Access Compliance Report

Public Rights-of-Way

Intersection ID: 11236	Main Street: N_CHURCH_ST	Cross Street: W_LIDDELL_ST	Location: E
ADA ID: 7B377E1AFB89	Ramp Type: Perp	Initial Pass/Fail: Pass	Overall Compliance: No
Codes/Mitigation Info/Possible Solution		Field Measurements/Component Compliance	
Severity Score: 19.25

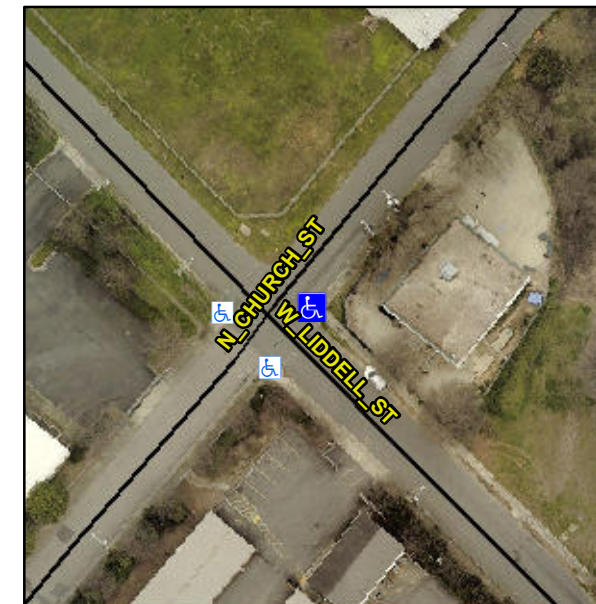
**R304.5.3, R304.2.1, R304.2.2-Perp,
R304.3.2-Para, R305.2, R302.7,
R302.7.2**

Compliance	Description	Data	Compliance	Description	Data
N/A	Ramp Length (in)	47.5	Yes	Ramp Slope (%)	7.7
Yes	Ramp Width (in)	97.0	No	Ramp XSlope (%)	3.0
N/A	Flare Type LT	Sloped	N/A	Flare Type RT	N/A
N/A	Flare Slope LT (%)	5.4	Yes	Flare Slope RT (%)	4.6
N/A	Flare Traversable LT?	Yes	N/A	Flare Traversable RT?	Yes
No	Landing Length (in)	22.0	Yes	DWS Provided?	Yes
No	Landing Width (in)	37.0	Yes	DWS Contrast?	Yes
No	Landing Slope (%)	4.0	Yes	DWS Length (in)	25.5
Yes	Landing X Slope (%)	1.7	Yes	DWS Full Width?	Yes
N/A	Landing Curb? (Y/N)	No	No	DWS Offset (in)	9.5
N/A	Shared Landing?	No			
No	Gutter Ponding?	Yes	Yes	Gutter Slope (%)	2.0
No	Gutter Lip Ht (in)	1.0	No	Gutter X Slope (%)	2.1
N/A	Painted X Walk1?	No	N/A	Painted X Walk2?	N/A
	X Walk 1 Direction	To SW		X Walk 2 Direction	N/A
N/A	X Walk 1 Width (in)	N/A	N/A	X Walk 2 Width (in)	N/A
	X Walk 1 Slope (%)	5.0		X Walk 2 Slope (%)	N/A
	X Walk 1 X Slope (%)	1.6		X Walk 2 X Slope (%)	N/A

N/A	Ramp inside XWalk1?	N/A	N/A	Ramp inside XWalk2?	N/A
	Road Slope (%)	N/A	N/A	Clear Space?	Yes
	Road X Slope (%)	N/A	N/A	Clear Space to XWalk (in)	N/A
Yes	Any Obstructions?	No	Yes	Storm Grate/Utility Hazard?	No
	Obstruction Type			Storm Grate/Utility Type	
		N/A			N/A
			Yes	Surface Condition? (G/P)	Good

**Remove & Replace Entire Ramp.
Remove & Replace Gutter.**
